REVIEW NOTES

PROPOSED IMPROVEMENT BRIDGE PROJECT

TOWN OF NEWFANE
COUNTY OF WINDHAM

PRELIMINARY PLANS
25-JUL-2016

STA. 51+25 TO STA. 51+75

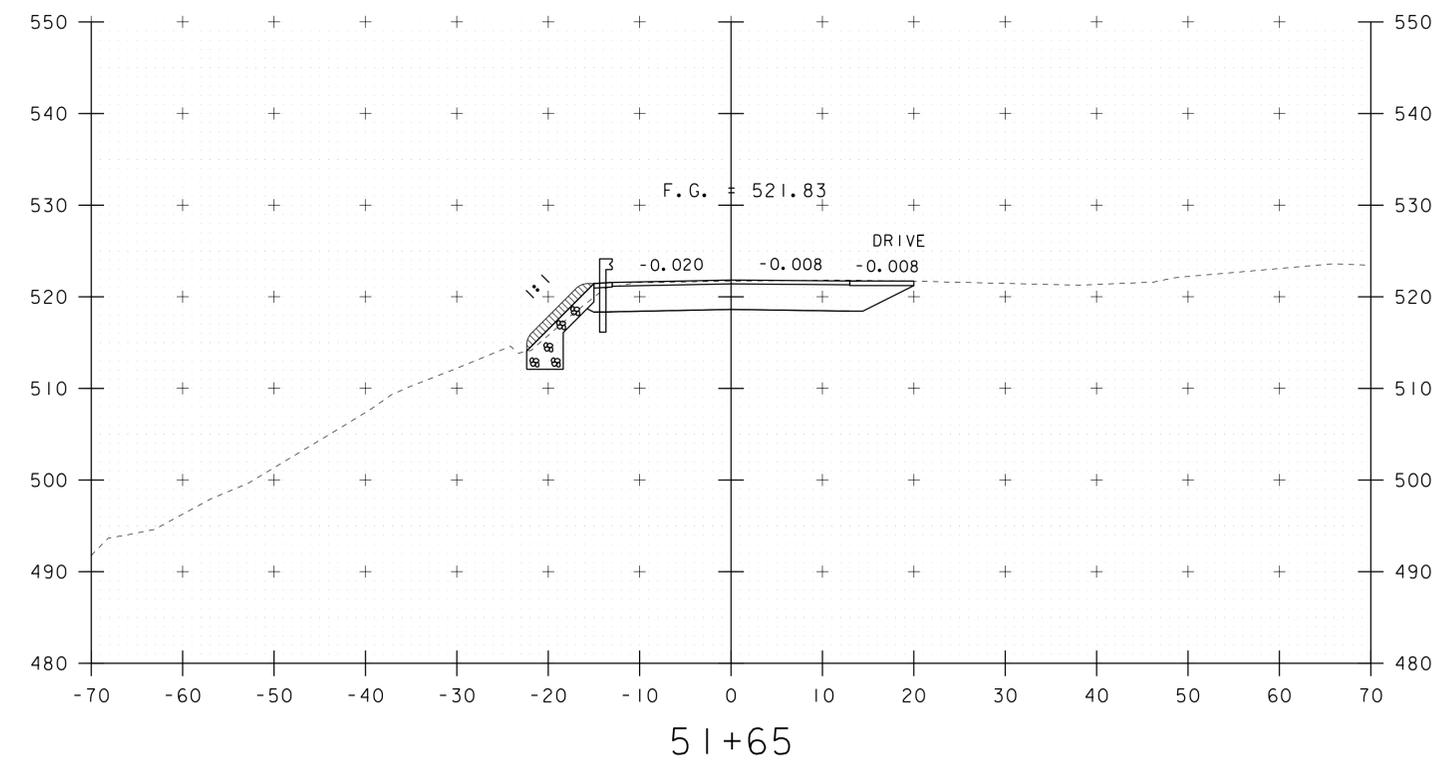
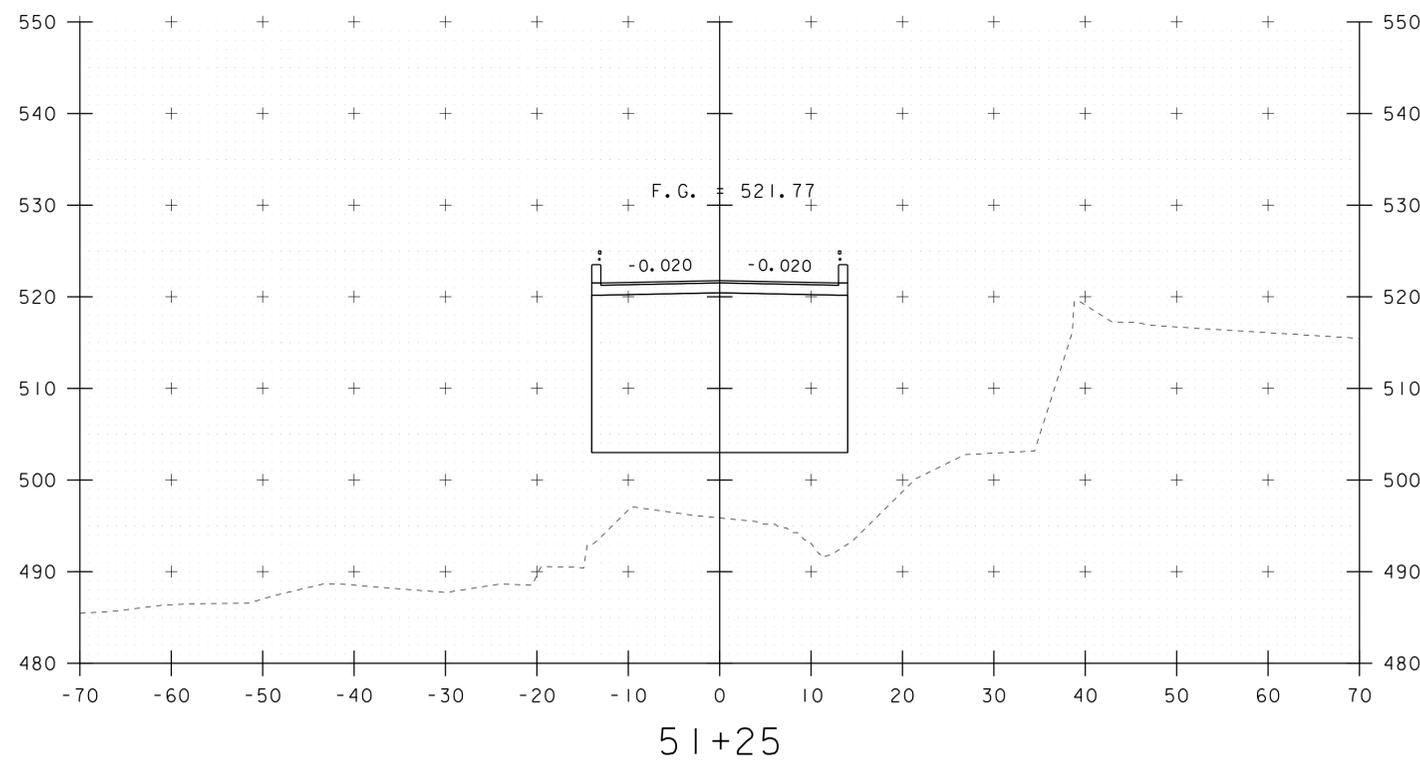
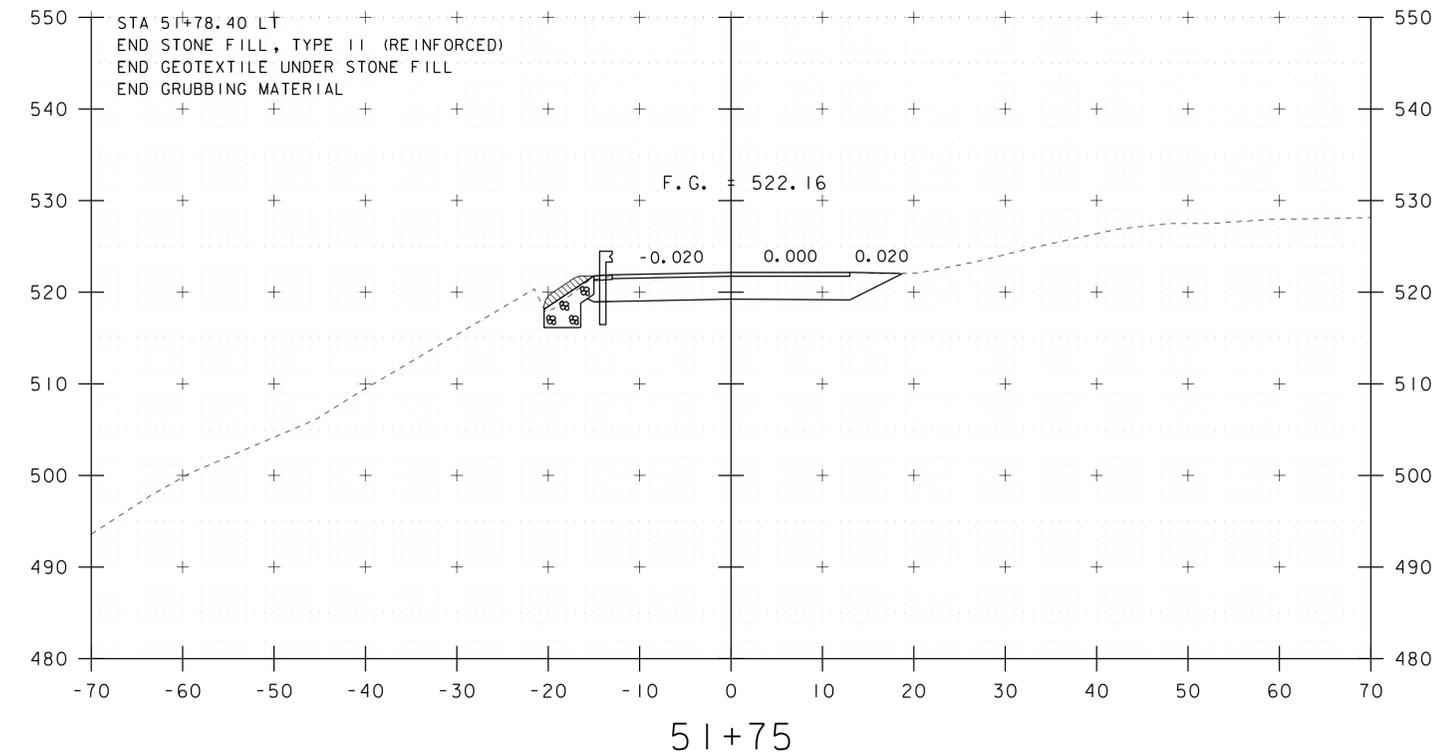
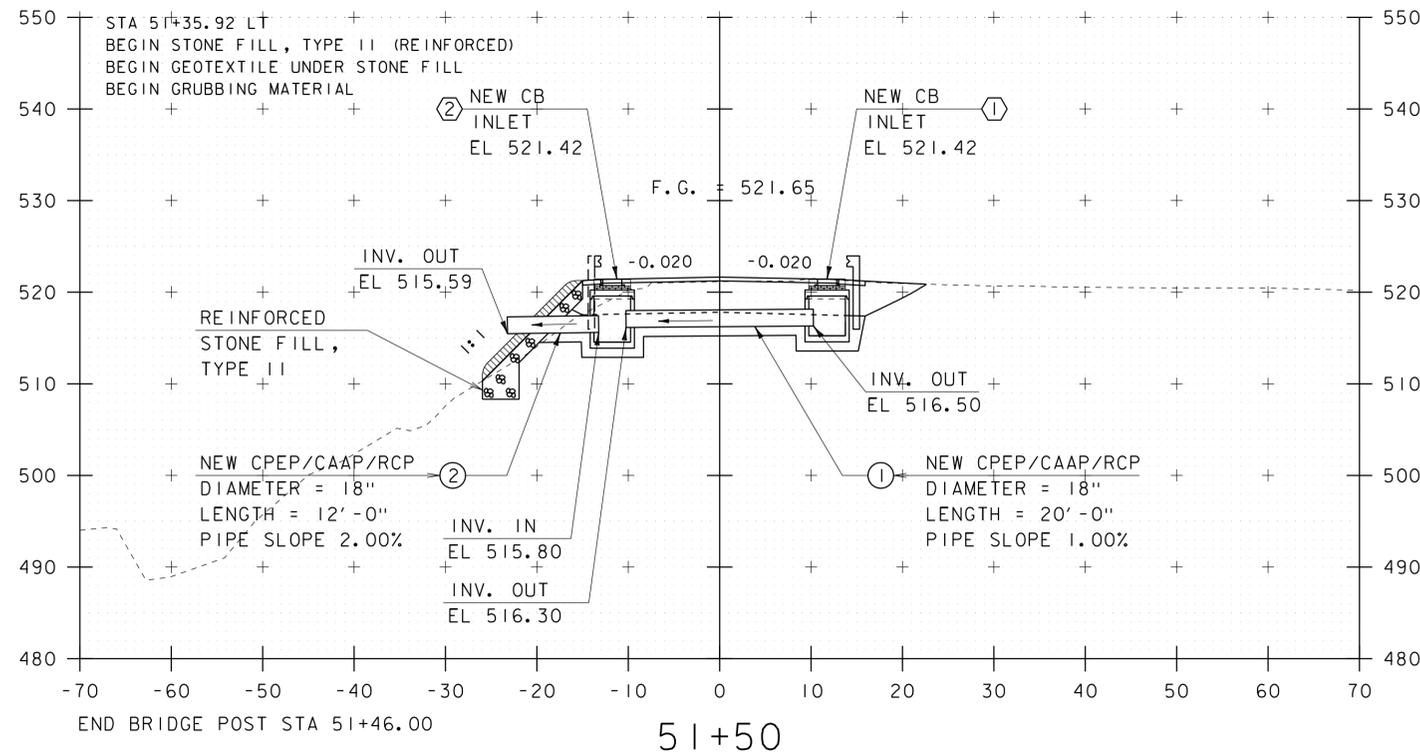
- 1) THE PROPOSED SIDE SLOPE AT WINGWALL 3 IS APPROXIMATELY 1:1 SINCE A 1:1.5 SLOPE WILL CARRY THE STONE FILL ALL THE WAY DOWN TO THE RIVER BED. THIS PROPOSED SLOPE MAY NEED TO BE REINFORCED AND THE GEOTECHNICAL SECTION MAY NEED TO TAKE A CLOSER LOOK AT AREA TO DETERMINE SLOPE STABILITY HERE. SEE CROSS SECTIONS 51+50 AND 51+65.
